OAK CREEK SUBDIVISION, GES PROJ. # 20-0102 - PRELIMINARY SITE PLAN - 01/28/2025

JSC2022-0003 PSC2023-0001 Revision #4 Received 2/25/2025

Site Plan Review

OAK CREEK SITE CONDOMINIUM

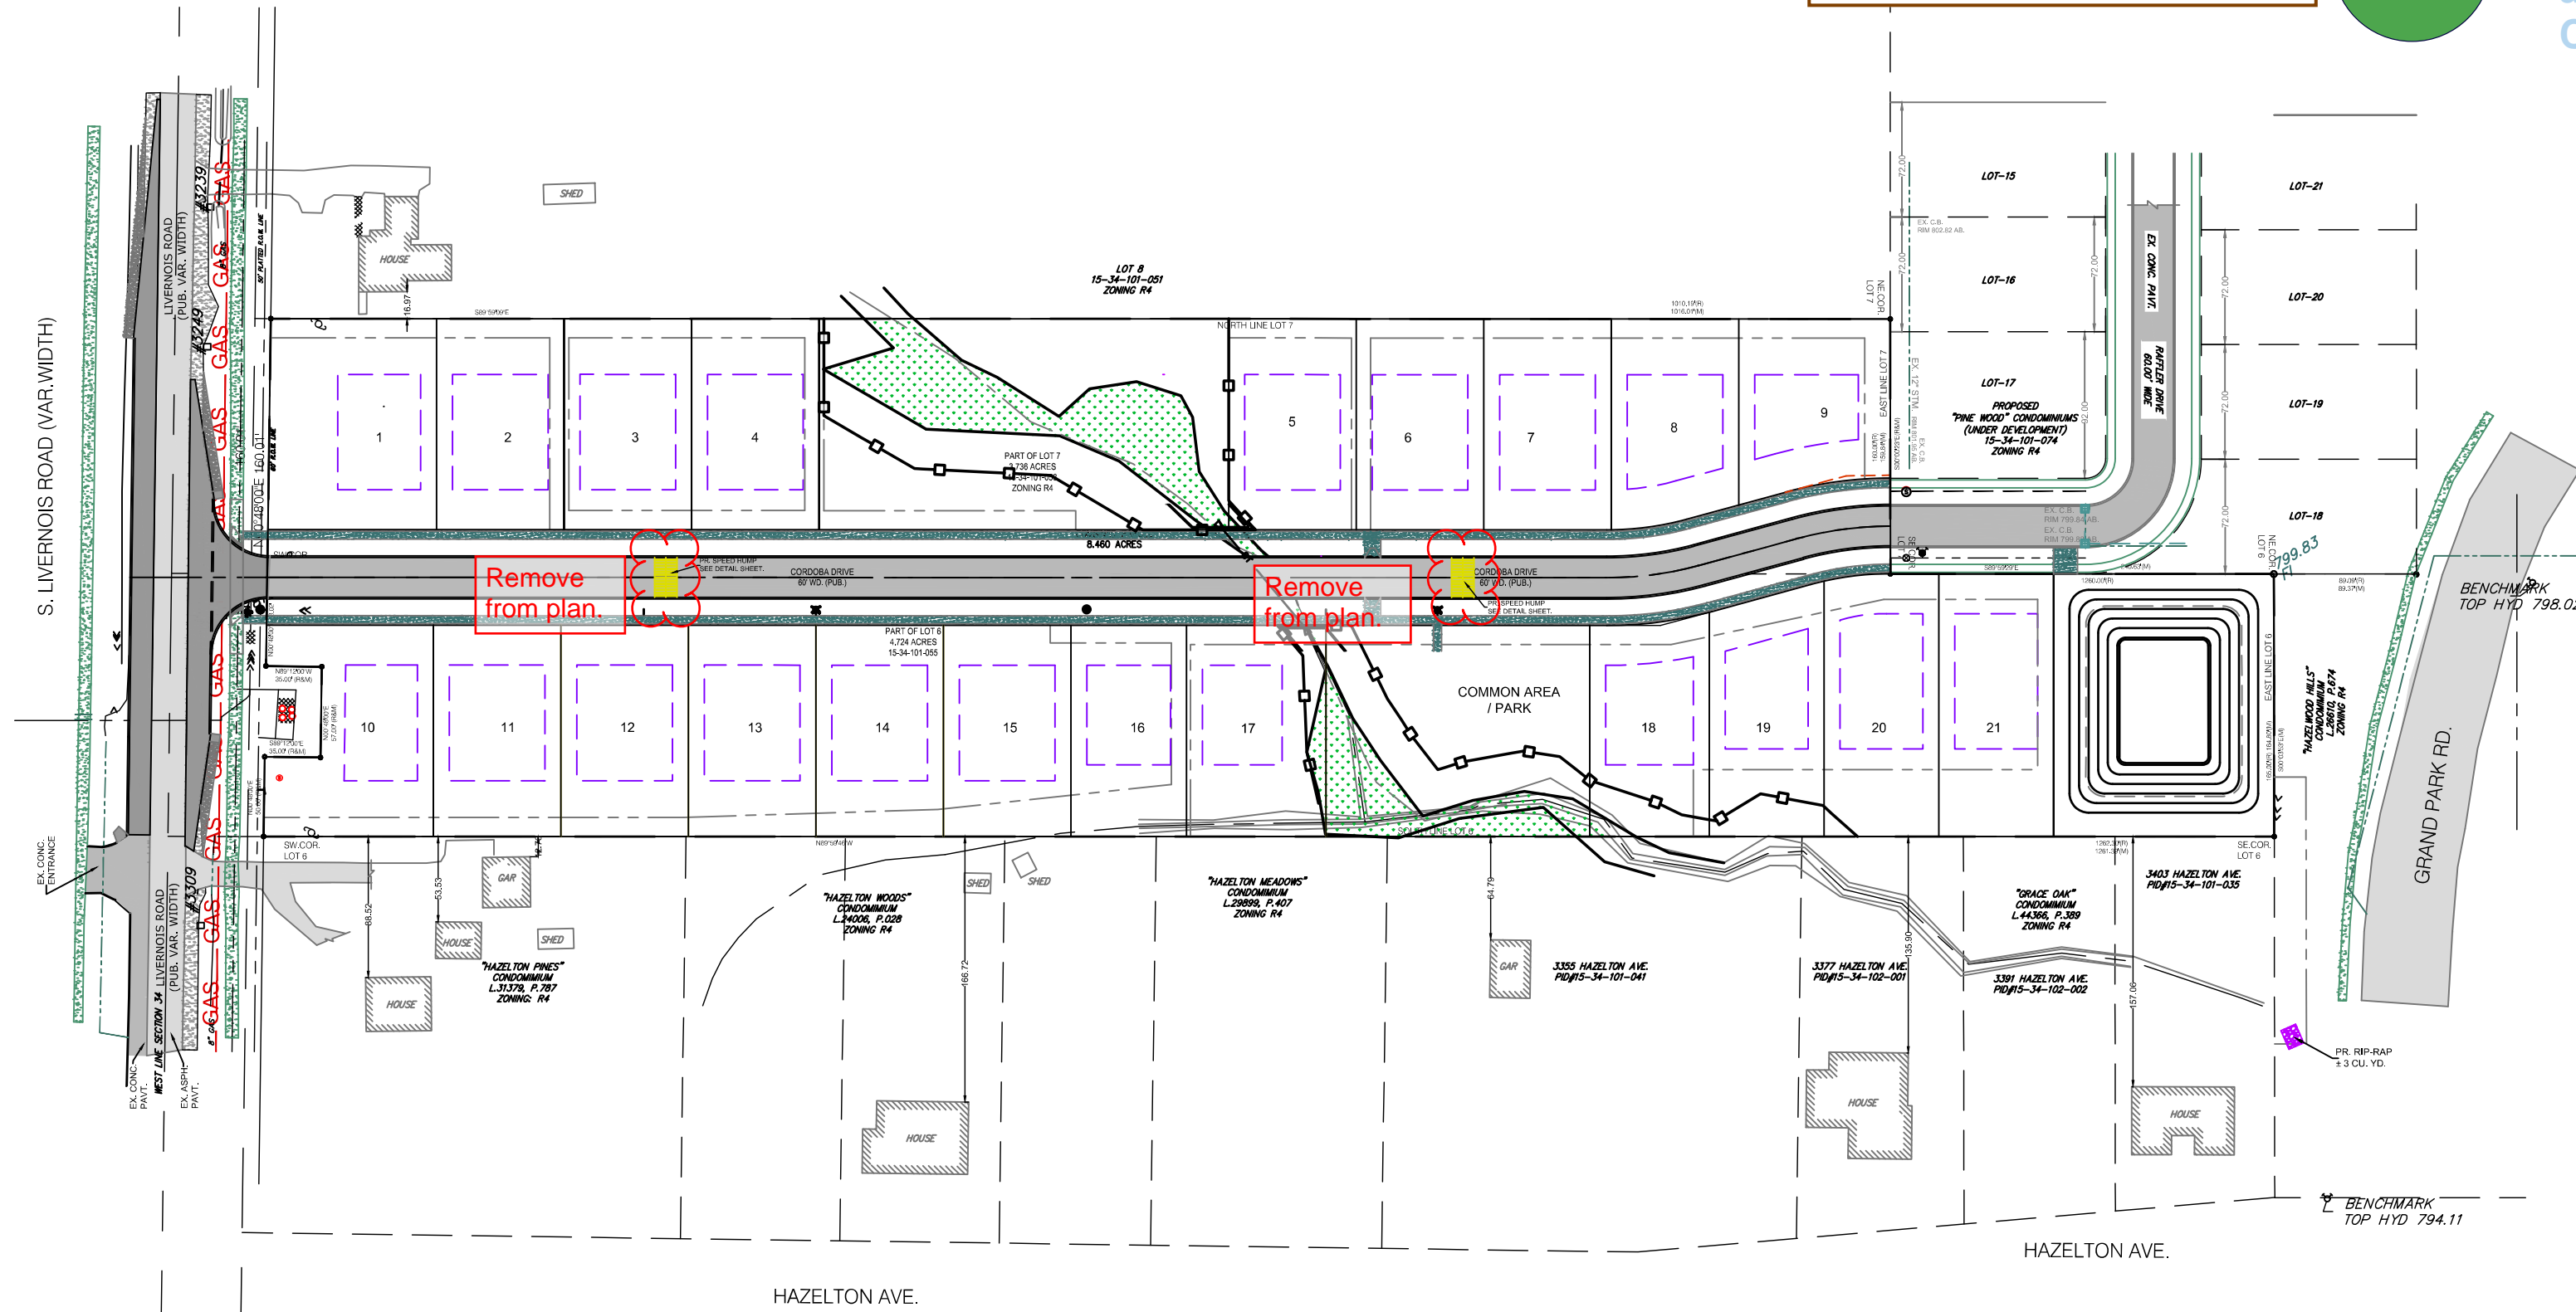
Provide updated landscape cost estimate prior to planning commission date.

The applicant will need to submit a Land Improvement Permit (LIP) application with engineer's estimate, fee and construction plans to proceed with the construction plan review process.
